November 5, 1993

SUBJECT: Response to FDEP Request for Information
Regarding: Operating Permit Application Renewal
Permit No. UO 56-237554
North Port St. Lucie Injection Well IW-1

On behalf of St. Lucie County Utility Services Department (SLCUSD), Montgomery Watson is pleased to submit three copies of the response to the Florida Department of Environmental Protection (FDEP) Request for Information (RFI) regarding Operating Permit Application for Injection Well IW-1 at the North Port St. Lucie Injection Well System, Permit No. UO 56-237554, dated October 8, 1993.

FIGURE 10

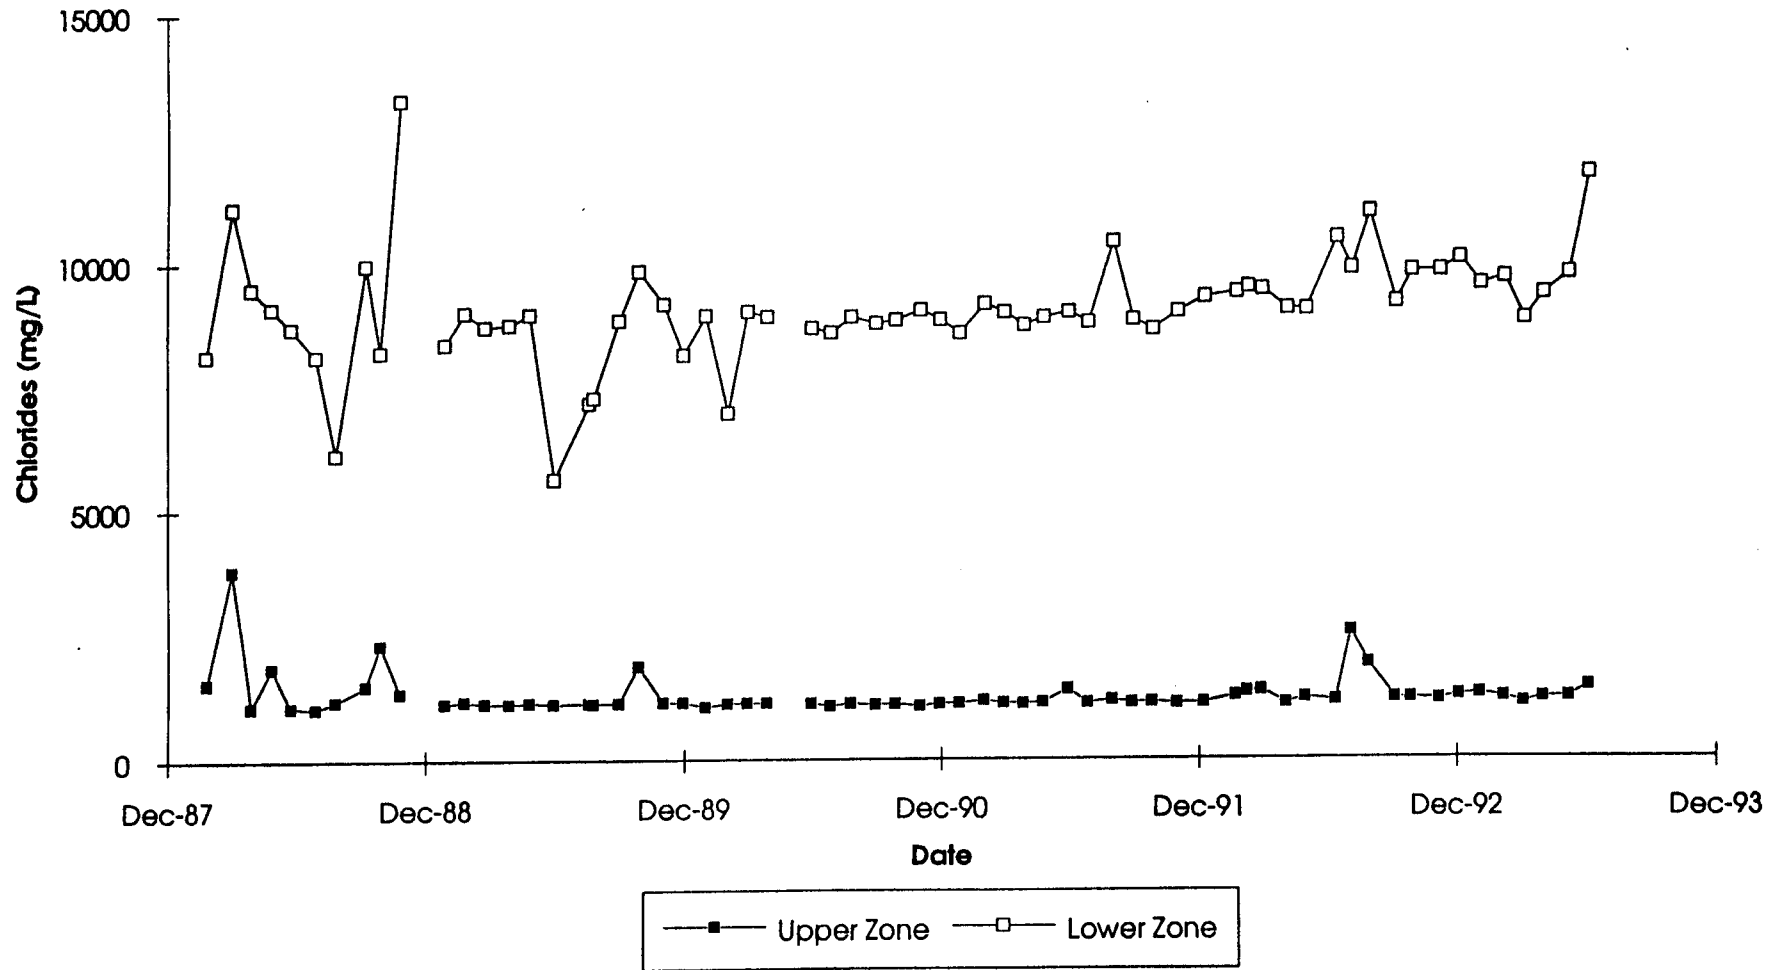
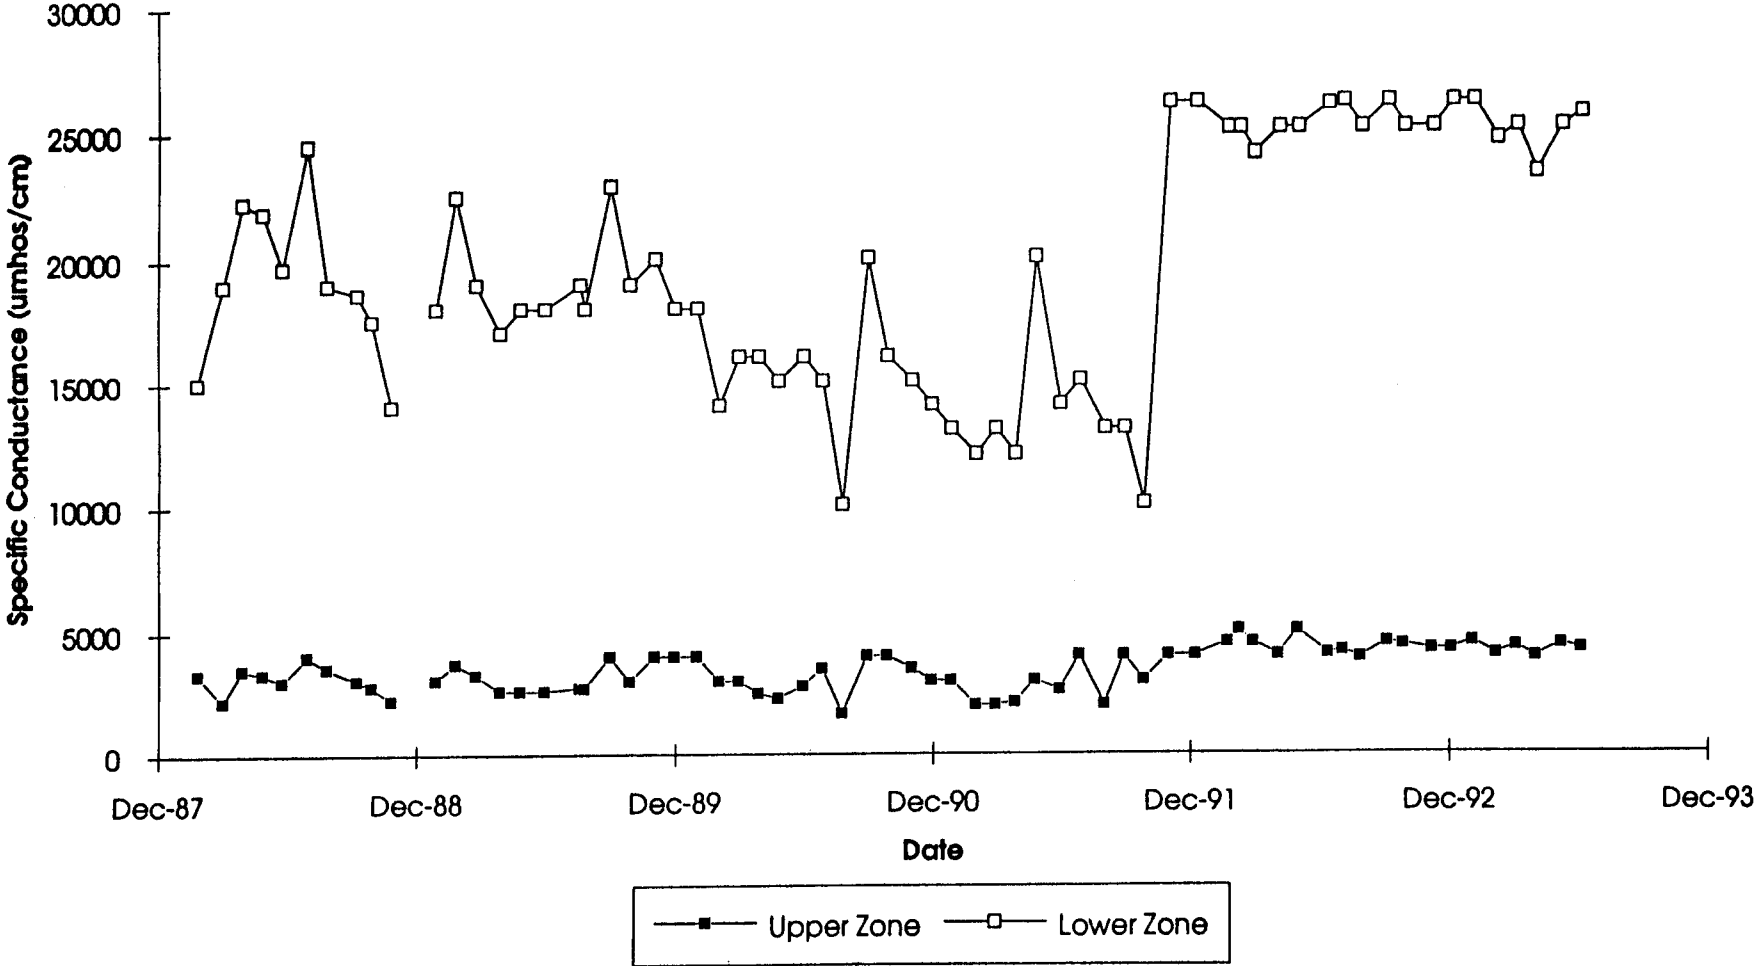
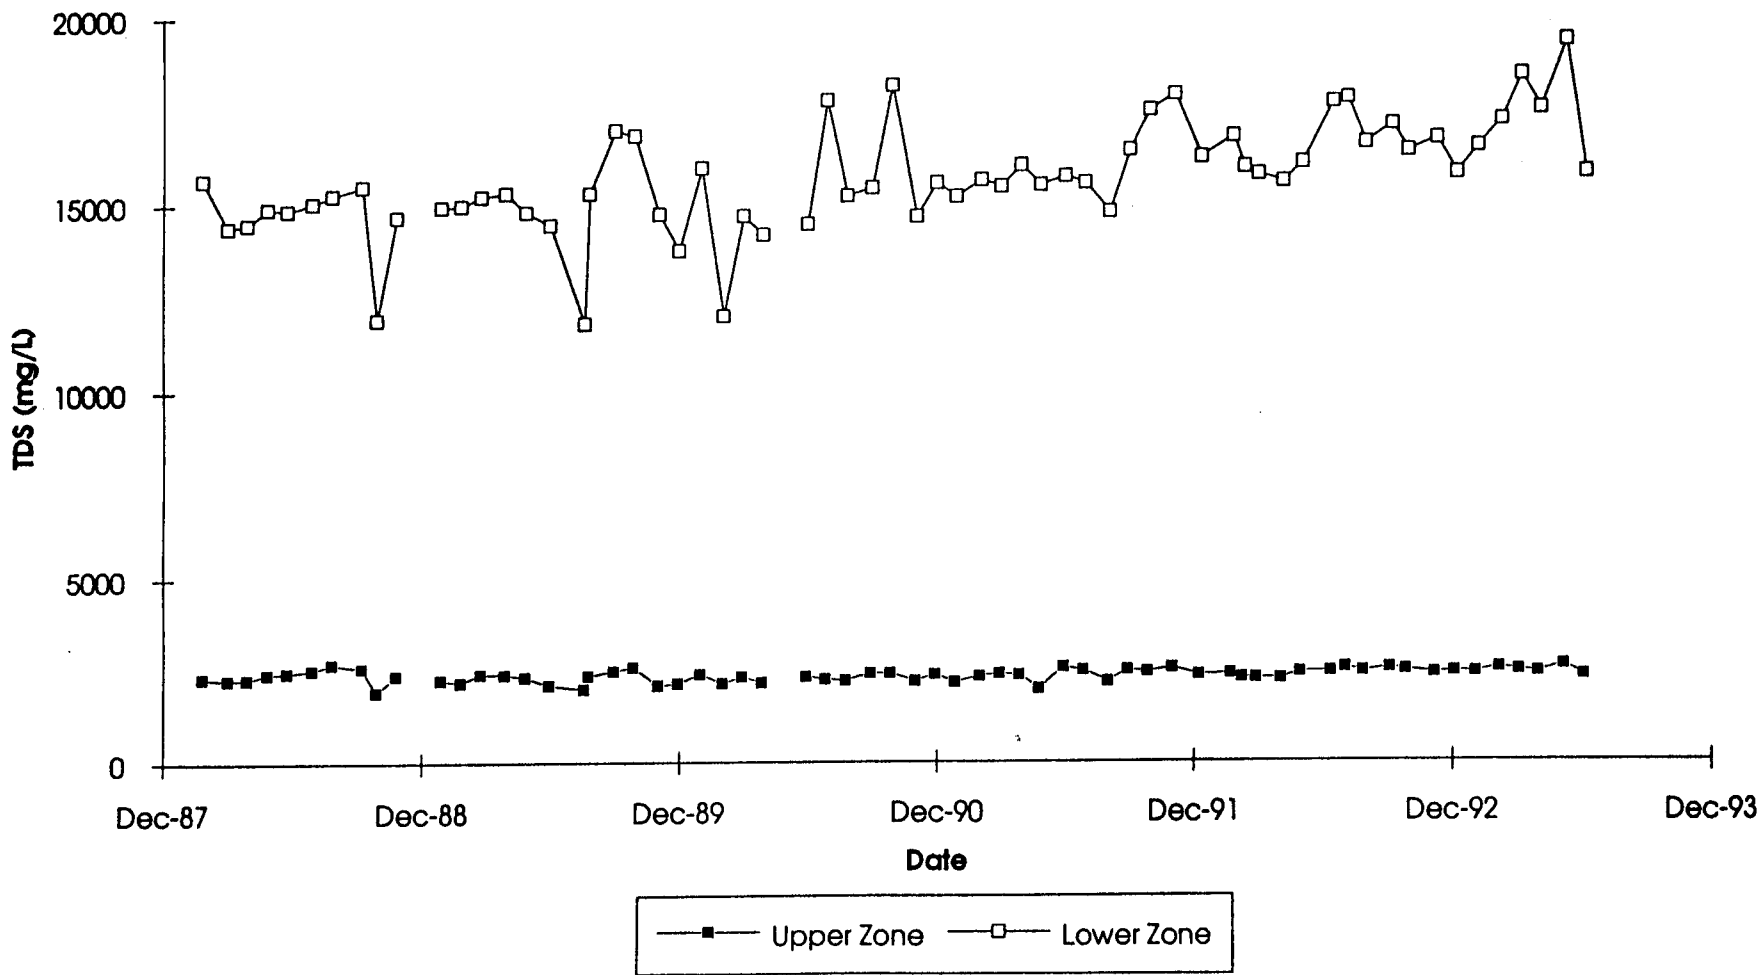
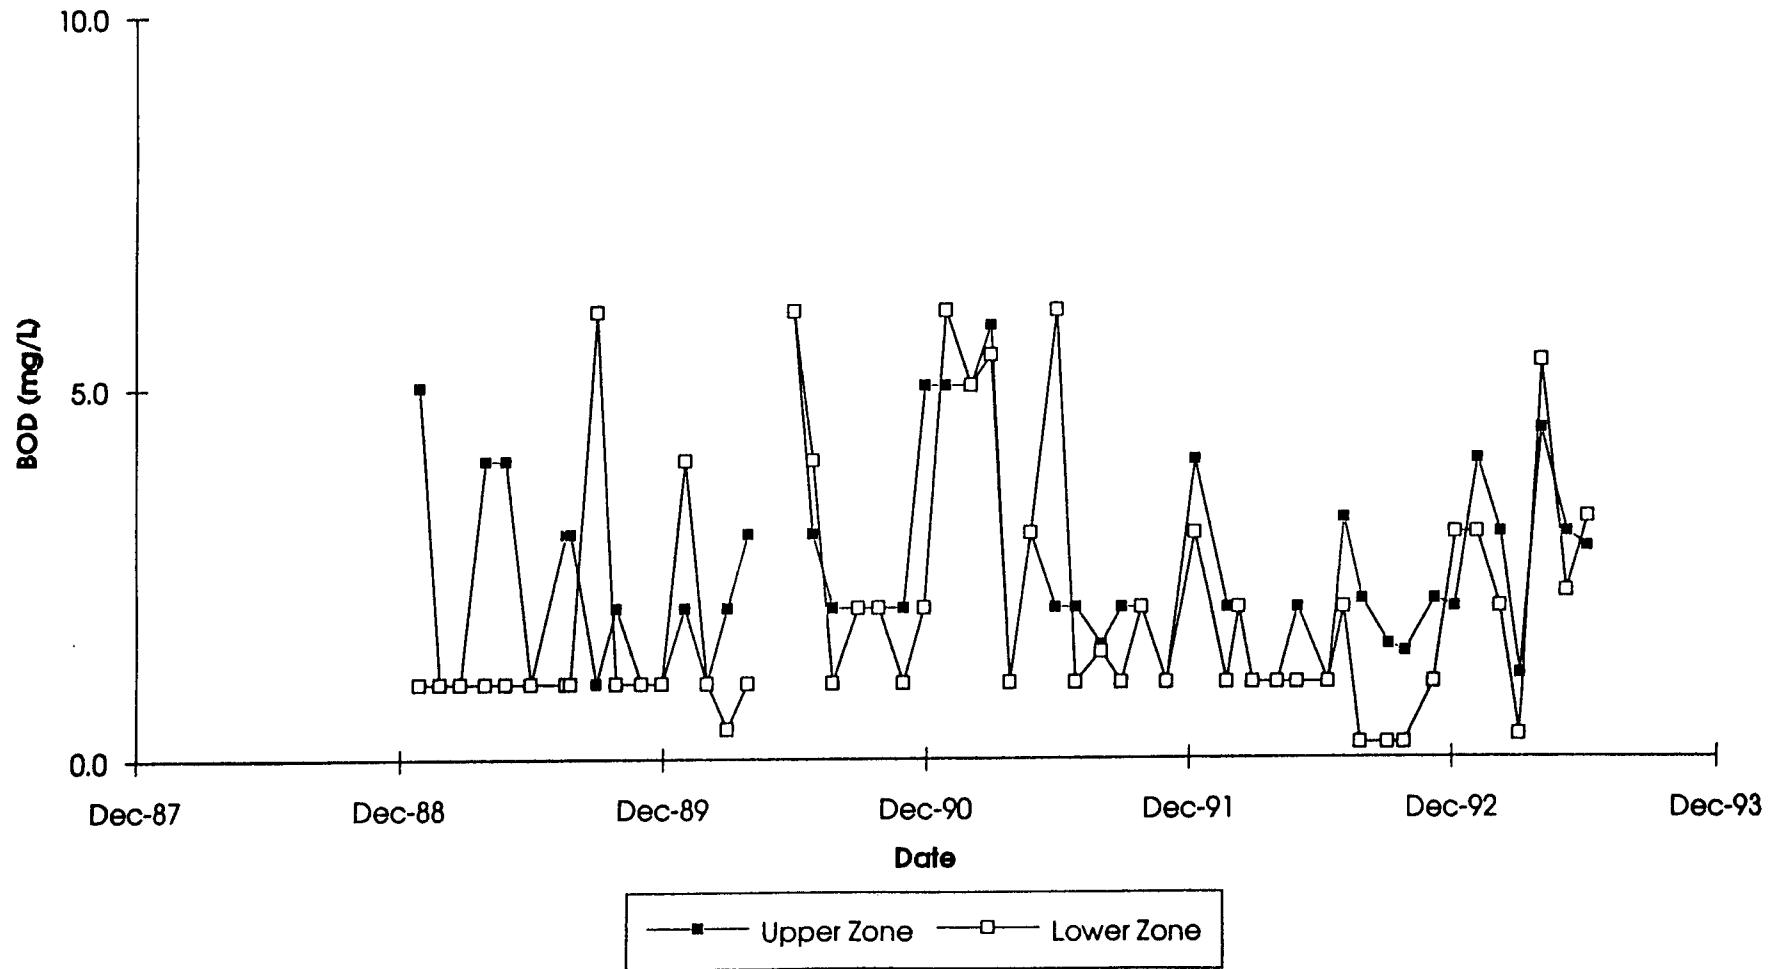
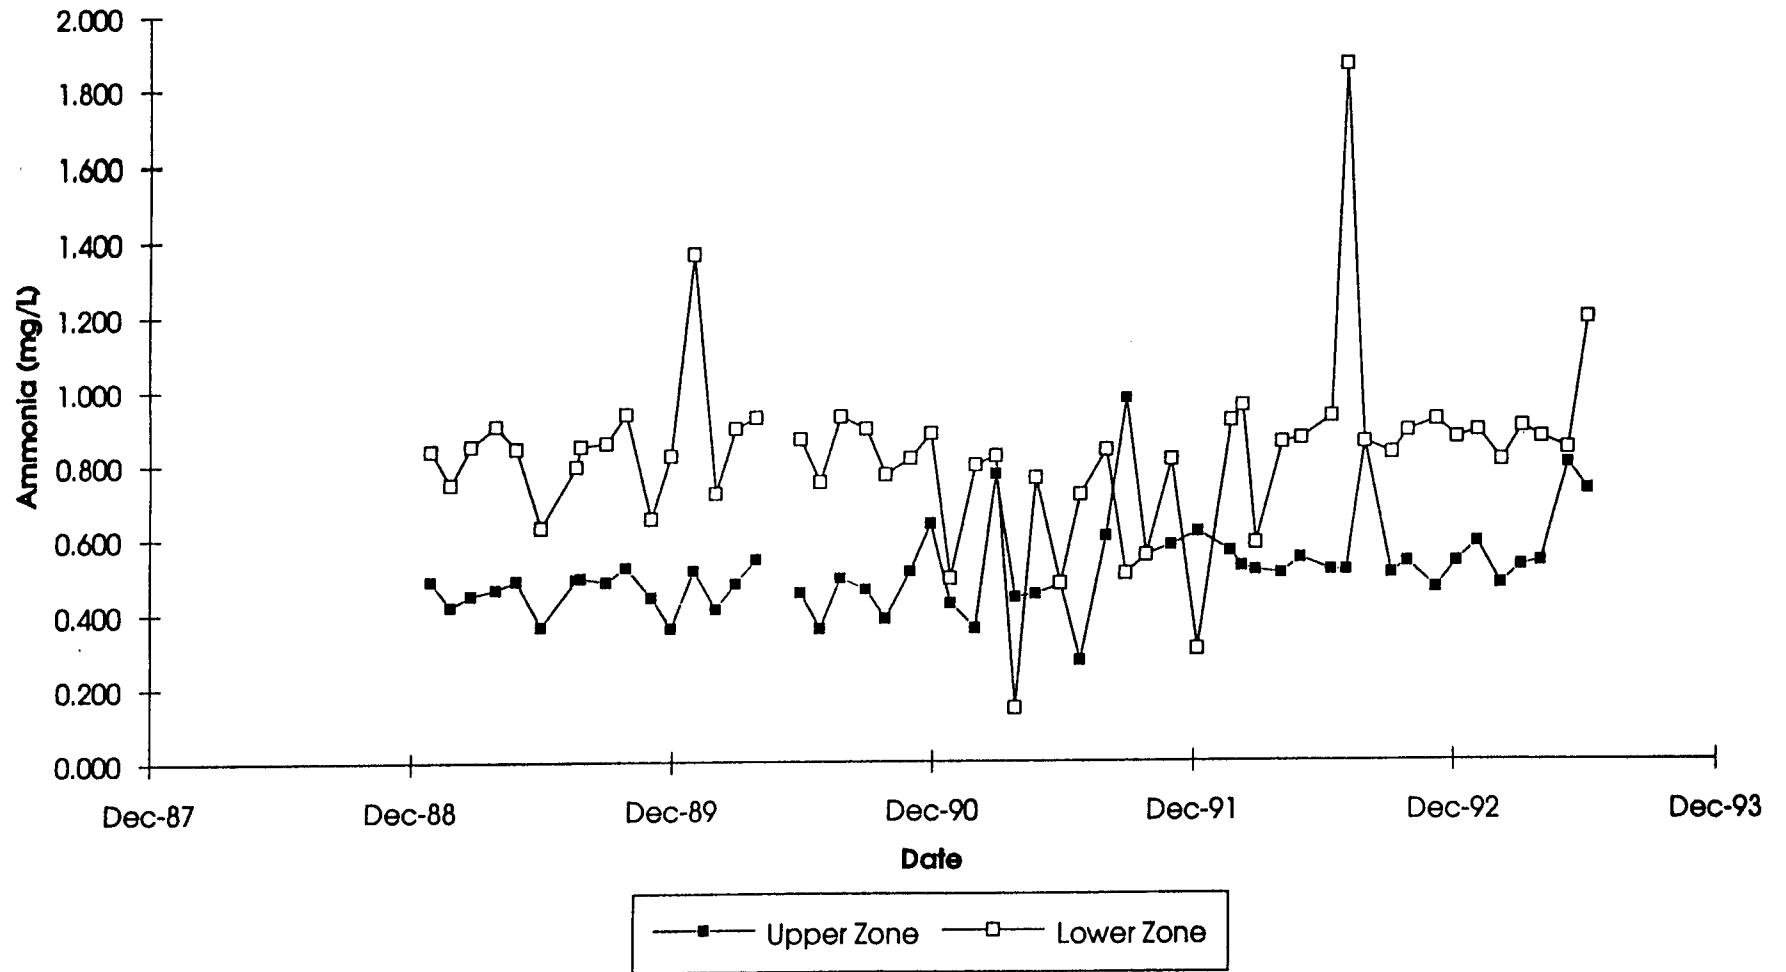
- 2. As required by Rules 17-28.210(1) (a) and (2) (a), F.A.C., an applicant for an injection well shall demonstrate the adequacy of confinement between the injection zone and the zones above the injection zone. This data will come from the information obtained during construction of the wells, but as required by Rule 17-28.340(1) (c), F.A.C., must be provided in this application so that it can be approved on its own merit. Within the area of review, maps and cross sections detailing the local geology and hydrogeology including the vertical and lateral limits of all underground sources of drinking water (USDW) are needed. Maps and cross sections illustrating the regional geologic setting are also needed.**

Testing section excerpted from the CH2M Hill report entitled "Drilling and Testing of the Deep Injection Well System," dated October 1987. In addition, review of NPSLIWS monitoring data in Attachment D, Figures 10 through 14 from the Montgomery Watson report entitled "Mechanical Integrity Testing of North Port Class I Injection Well," dated August 1993, and the conclusions from that report confirm confinement between the Injection Zone and the Lower Monitor Zone.

Graphs showing upper and lower monitor zone chloride concentration, conductance, TDS, BOD, and ammonia appear in this report as Figures 10, 11, 12, 13, and 14, respectively. No fecal coliforms have been detected in the upper and lower monitor zone samples throughout the period of record, so a graph of these data was not constructed.

Chloride (Figure 10). There appears to be no discernible trend in chloride concentration in the upper monitor zone. There is a very slight increasing trend in chloride concentration in the lower monitor zone, however. This trend would not appear to be significant in terms of mechanical integrity, because a leak from the injection zone to the lower monitor zone probably would result in a decrease in chloride concentration, rather than the reverse. However, slow upward movement of saline water from the injection zone might indicate upward movement of the injected fresh water. No other evidence currently suggests that upward movement of freshwater from the injection is occurring, however.

Specific Conductance (Figure 11). Conductance in samples collected from both upper and lower zones show a slight increase over the last year and a half of record, since December 1991. An especially sharp increase in specific conductance occurred in December 1991. The reason for this might be the acquisition of a new conductance probe by St. Lucie County in late October 1991. Prior to that, widely fluctuating values in the lower zone seemed to indicate an overall decreasing trend. These trends, by comparison with other measured parameters would seem uninterpretable in terms of actual changes in the water quality of the actual monitor zones, so might have indicated a problem with the measuring device.
